Monterey County

Board Order

(Appeal of a Design Approval - PLN120348/Merritt, 24505 South San Luis Avenue, Carmel, Carmel Area Land Use Plan, Coastal Zone)

Resolution No. 12-244

EXHIBIT 2

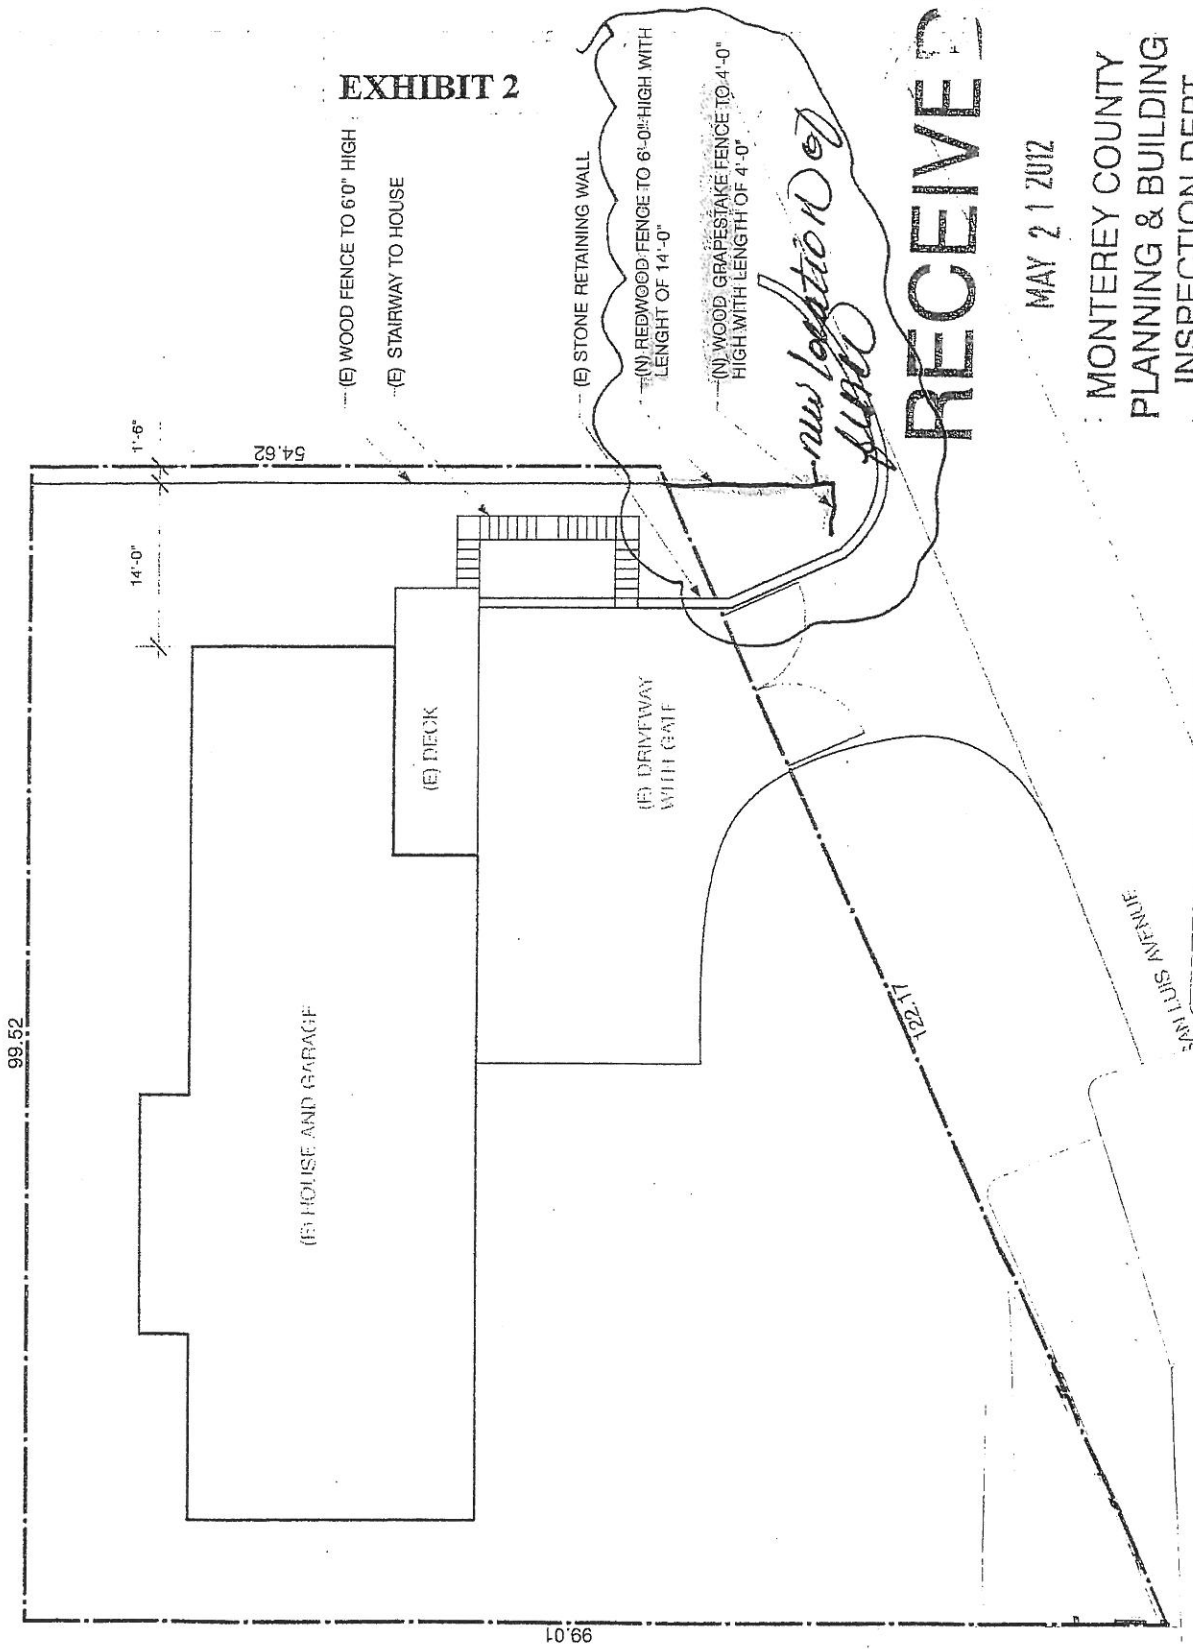
- a) The submitted design drawings appear to be incomplete and do not show the front, side and rear elevations as required by Section 20.44.030.B.1.*
- b) The overall height of the proposed 6-foot fence is actually 10 feet-6 inches tall at the street and 13 feet tall at the rear of the fence.*
- c) The appellant's landscaped terrace, which has been present for more than 50 years, will lose most of its sunlight.*
- d) A compromise between the County, the appellant and the applicants should be sought since the project affects two County homeowners and is built on County land.*

- a) *The submitted design plan is incomplete because the location of the current landscape and trees are not shown on the plan as required by Section 20.44.030.B.3. The landscaping is germane to the appeal because the terraced area has been landscaped for more than 50 years and the new location of the fence would disrupt the landscape.*
- b) *The original fence location was located approximately 6 feet to the west of the new location.*
- c) *The original fence was wire and only 3 feet high.*
- d) *Requests that new fence should match the existing fence (grapestake). The proposed fence is a continuation of the existing fence but it does not match.*

- a) *The application states that applicant is replacing a portion of a fence when in fact, they want to create a new fence line 6 feet away from the fence they say they want to replace.*

- c) *The new fence would go through an established landscaped terrace. The plan does not show location of fence being replaced. Appellant would not object to fence in same location as original fence.*

- a) The purpose of elevations is to show what a proposed structure will look like. In this case, photographs of the proposed fence submitted with the application clearly show the color, materials and relationship of the proposed fence to the surrounding topography and landscaping. The applicant constructed the fence without first obtaining the required Design Approval. In order to clear the resulting violation, (Code Enforcement Case No. 12CE00119), the applicant removed the fence. Once the CE case was closed, the applicant submitted the application for Design Approval to re-construct the fence in the same location using the same materials. The photographs submitted with the application, which were made prior to the removal of the fence, provided sufficient information to evaluate the application.

- b) It is the RMA-Planning Department practice to measure height of a structure from the immediately adjacent grade. The fence does not exceed 6 feet tall as measured from the immediately adjacent grade. The appellant's measurement includes the height of a portion of a stone retaining located adjacent to the appellant's driveway which leads to the appellant's below-grade-garage. The fence is located several feet away from the stone retaining wall.

- a) The purpose of showing existing landscaping on the plans is to show the relationship between the landscaping and the proposed structure. In this case, photographs of the proposed fence submitted with the application clearly show the relationship of the proposed fence to the surrounding topography and existing landscaping (See Staff's Response No. 1 above). As noted above, the terrace had recently been re-landscaped. While the mature trees and shrubbery that were removed may have been more than 50 years old, the existing landscaping is new.

- b) The original fence consisted of two sections: 1) Section 1 is a 5 to 6-foot tall fence that extends generally along the common property line between the two properties from the rear property line to approximately 4 feet from the front property line; and 2) Section 2, which jogged west into the applicant's property for a few feet and then ran parallel to the property line and the extension of the property line within the public right-of-way for approximately 19

- c) The plan submitted with the application does not show the location of the fence being replaced, however photographs of the original fence were submitted and it is evident in the photographs that the original fence was located a few feet to the west of the proposed fence. As noted in Staff's Response 1(c) above, the terraced area in question was recently re-landscaped. The one remaining mature Monterey cypress tree in the public right-of-way was located to the east of the original fence and is located to the west of the new fence.
